FORD:
2005-2010 Mustang

This article supersedes TSB **8-2-10** to update the production fix date, vehicle model years and part list.

TSB 09-18-16 (Continued)

Figure 1 - Article 09-18-16

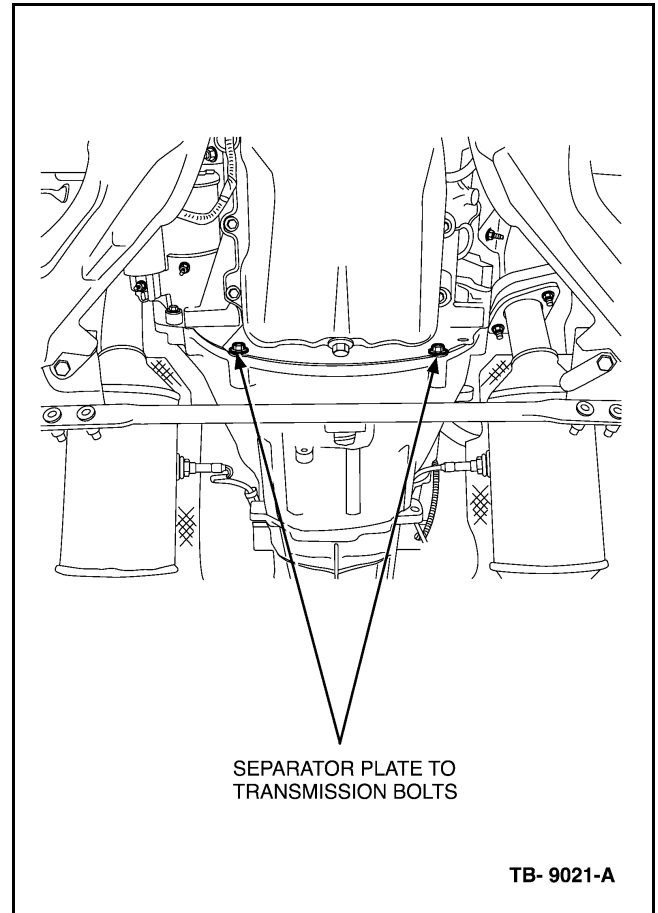
INSTALL NEW SEPARATOR PLATE TO TRANSMISSION BOLTS IF MISSING OR DAMAGED. (FIGURE 1)

1. Remove transmission per Workshop Manual (WSM), Section 308-03B.
2. Pry separator plate from the rear face of the block alignment dowels and slide it out from between block and flywheel. Replace with new service part.
3. Install transmission per WSM, Section 308-03B.
